## SERVICE BULLETIN

**APPLICABILITY:** 2017MY Impreza  
 2015-17MY WRX and WRX STI  
**NUMBER:** 06-65-18R  
**DATE:** 09/24/18  
**SUBJECT:** “Clicking” or “Ticking” Sound from VDC Hydraulic Control Unit  
**REVISED:** 07/16/19

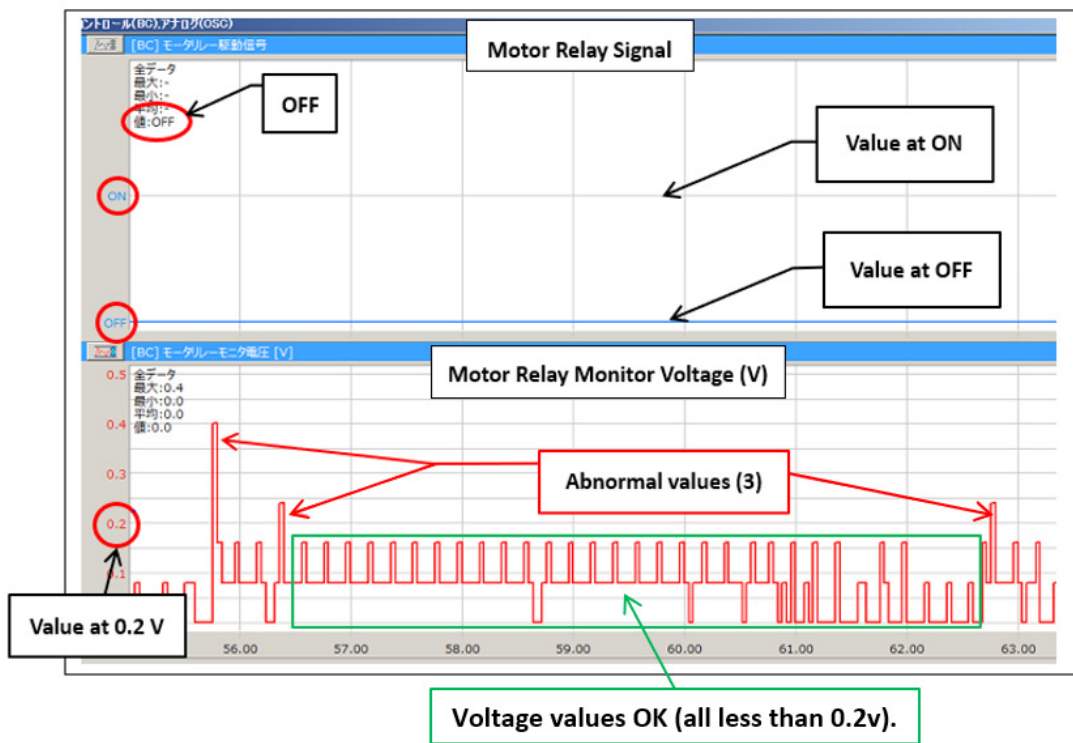
**Step 2:** Connect the SM4 and access data monitoring for the Brake Control system. Select the data for Motor Relay Signal and Motor Relay Monitor Voltage (V) as shown in the image below.

- **Scenario 2:** Inspect the value for Motor Relay Monitor Voltage. If any “spikes” of voltage exceeding 0.2v are identified while the Motor Relay Signal shows either ON or OFF, the VDCCM&HCU must be replaced.

**Step 3:** If either **Scenario 1** or **2** described above is confirmed, the VDCCM&HCU must be replaced.
